Application of SAWA Partners, LLC c/o Teweldemedhin Gebremeskel for a Special Land Use Permit (SLUP) to allow a recycling plant (recycling concrete business) in the M (Industrial) zoning district, at 1313 and 1303 Lithonia-Industrial Boulevard.

PETITION NO: D2-2026-0146 SLUP-26-1247921

STAFF ANALYSIS

REPLY TO STAFF ANALYSIS

OVERALL - INITIAL EROSION SEDIMENTATION & POLLUTION CONTROL PLAN I

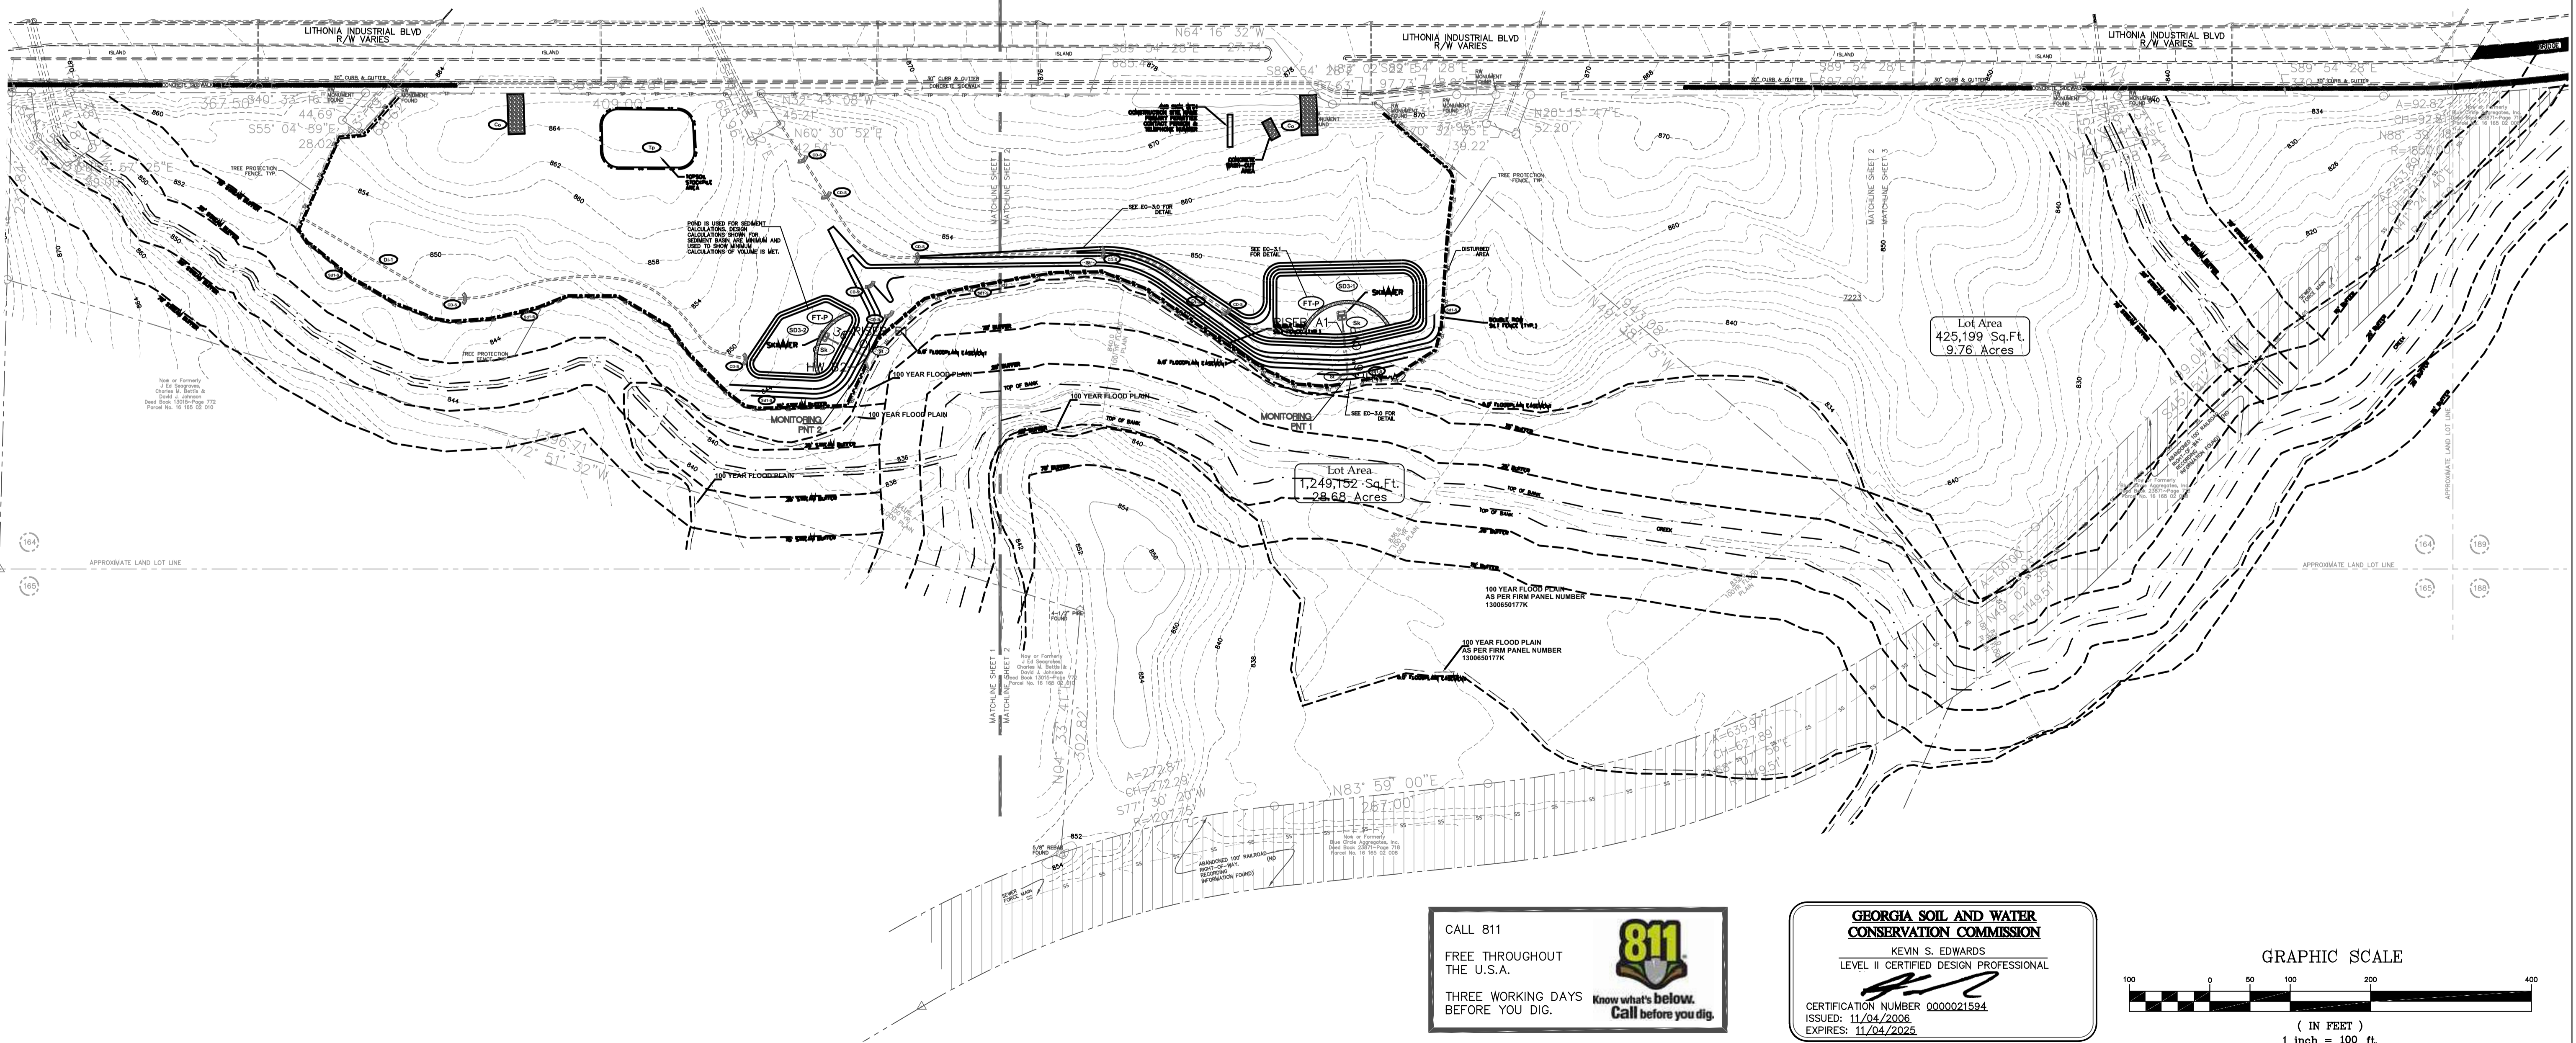
4. Any future SLUP approval will require that the existing structure on site obtain a building permit. Clarify on plan if the existing structure complies with minimum building setbacks.

5. Show how trucks will enter and exit the property, noting on the plan where the paved surfaces for the transportation equipment storage will be located, and clarify whether the secondary curb cut off Lithonia Industrial Boulevard will be used for the proposed operation.

- The property contains floodplain and flood way.
- Will there be any tree canopy preservation?
- What measures are taken to minimize air pollution?
 - **A water truck will be utilized during operating hours to control dust. Also, the crusher has a water sprayer to control dust.**

As per our site plans, we will comply with all requirements for obtaining a building permit.

- **The entrance into property is already paved with concrete. According to our site plans, and the site plan shows the entrance and exit will be paved with concrete. Also a secondary curb cut off will be necessary for a exit out of the property.**

- **Base Material:** Used for constructing road bases, driveways, and sidewalks.
- **Aggregate for New Concrete:** High-quality processed concrete can replace virgin aggregate in new concrete mixes.
- **Landscaping:** Crushed concrete serves as a cost-effective alternative to gravel in landscaping, such as in retaining walls or walkways. This process reduces landfill waste and the need for new aggregate mining.
- What measures will be taken to prevent downstream contamination?
 - **The site has two sediment ponds.**

INITIAL EROSION & SEDIMENTATION & POLLUTION CONTROL PLAN II

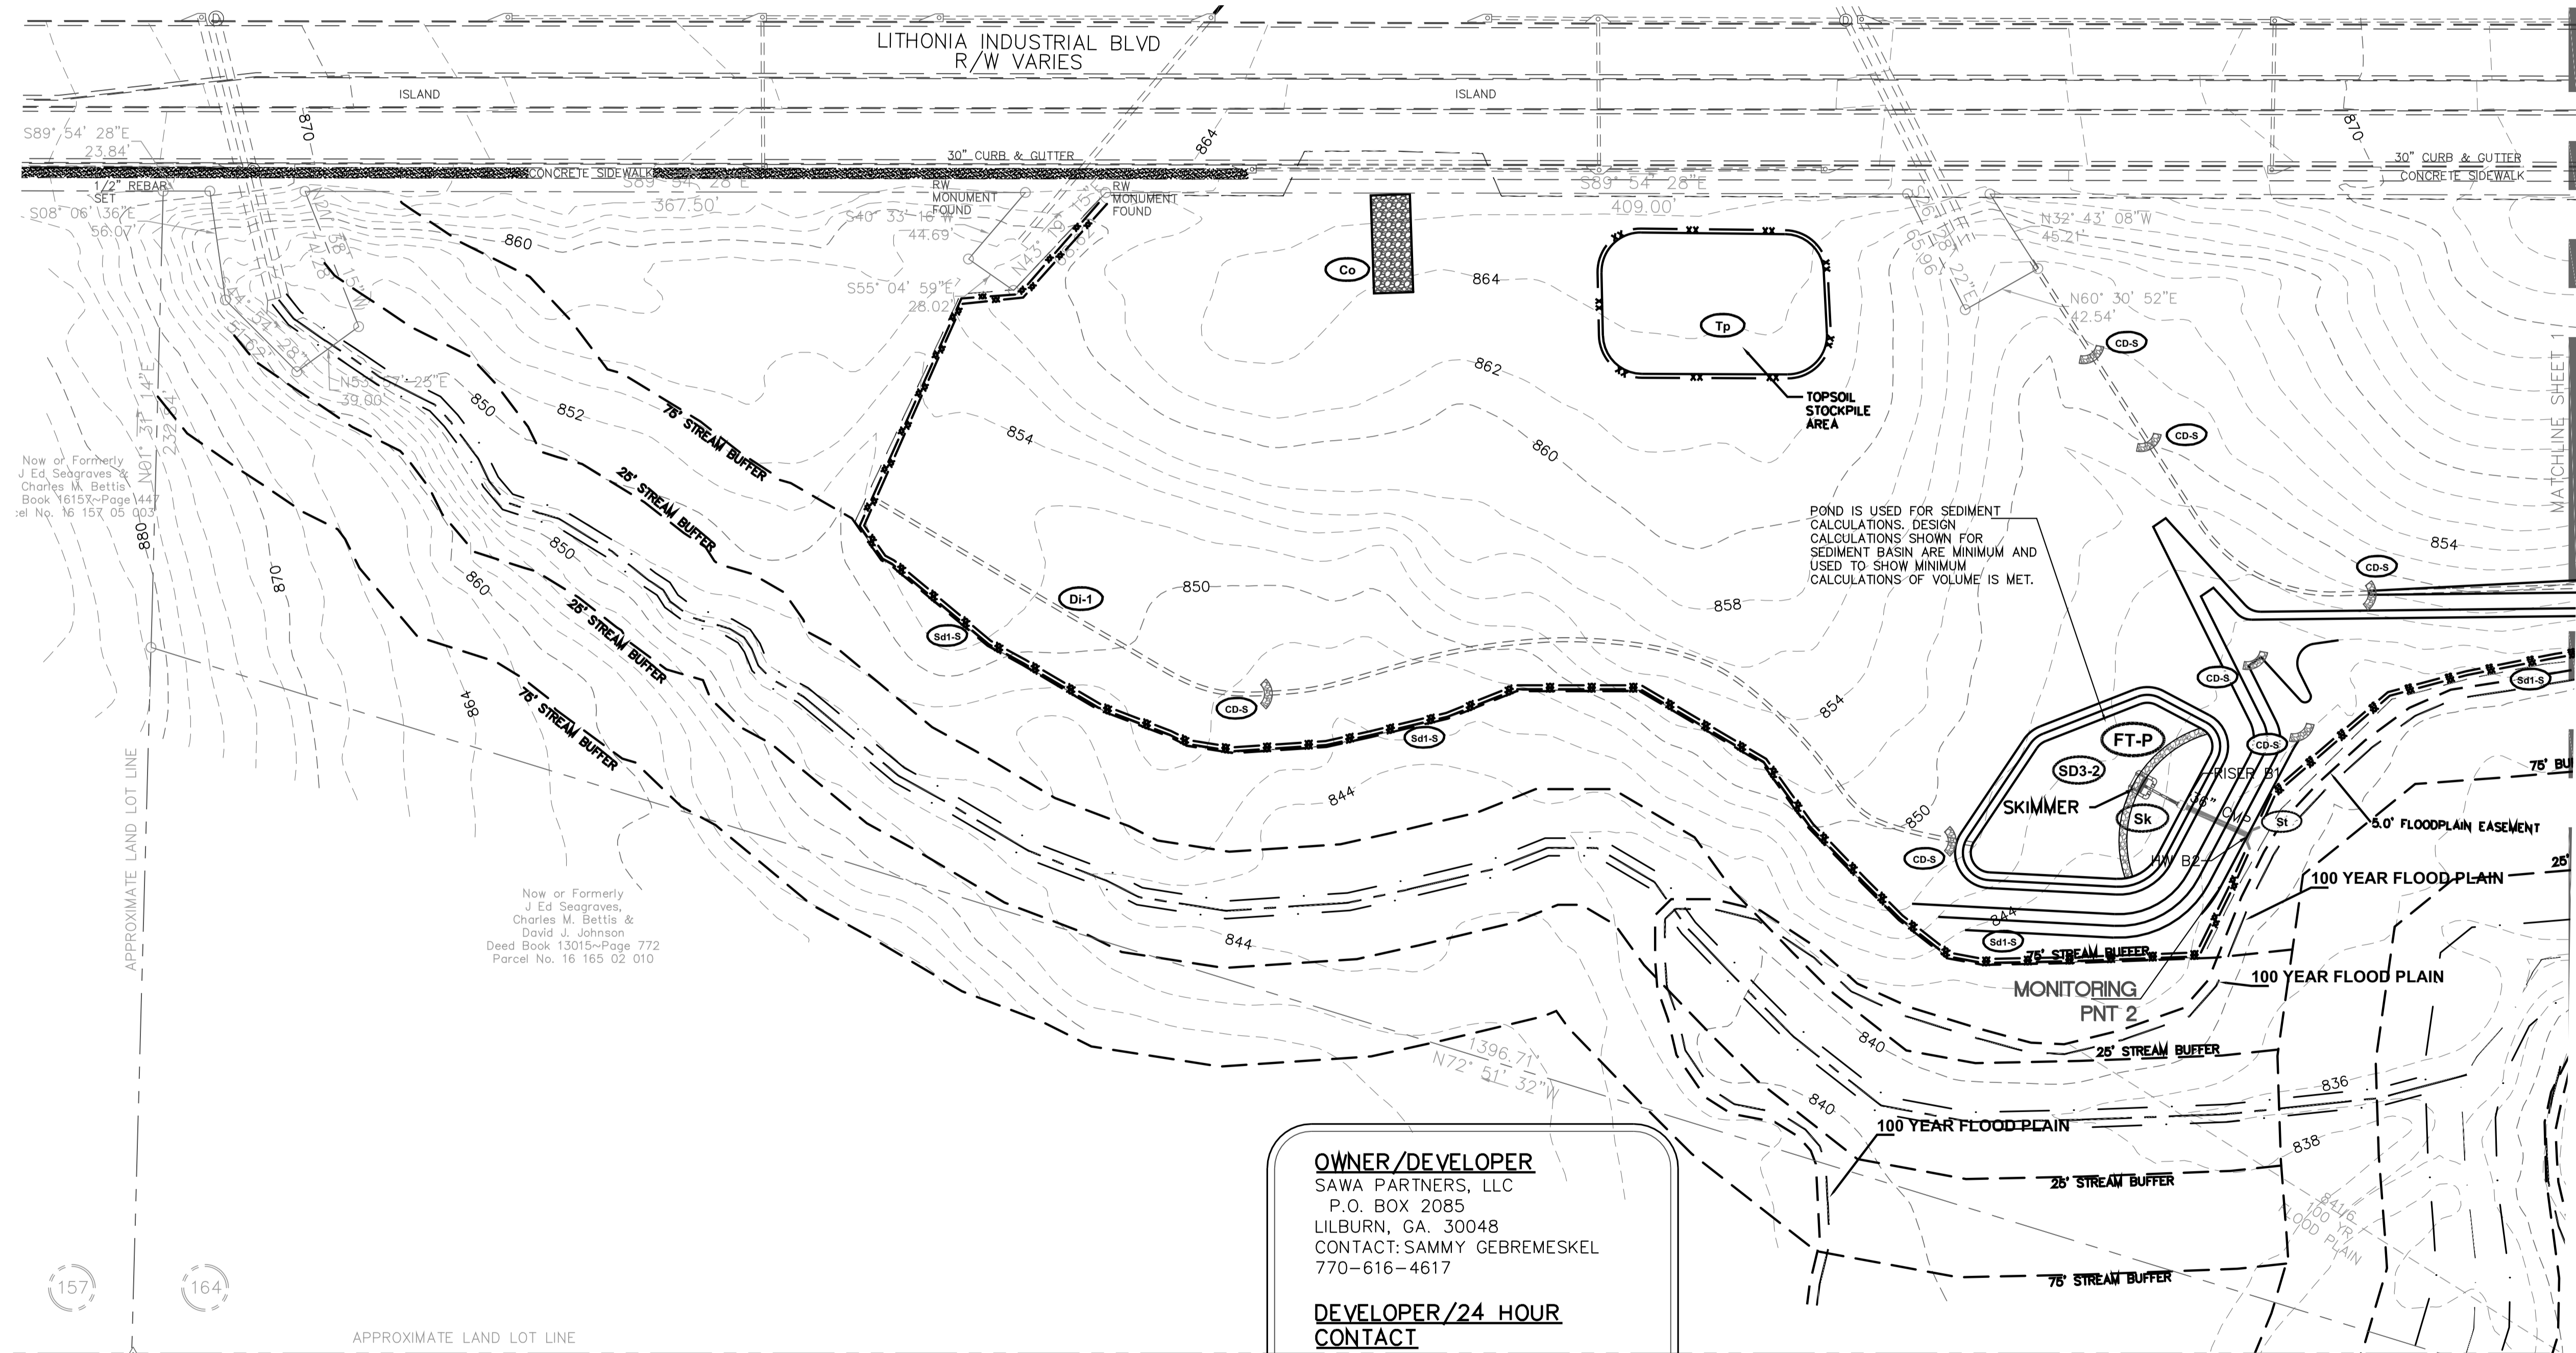
Lithonia-Industrial Boulevard is classified as a “Minor Arterial” road. Not enough information to properly review. Access points were set based on the Lithonia Industrial Blvd Road Plans. Applicant does not show interior routes on plans. Streetlights will be required on Lithonia-Industrial Boulevard.
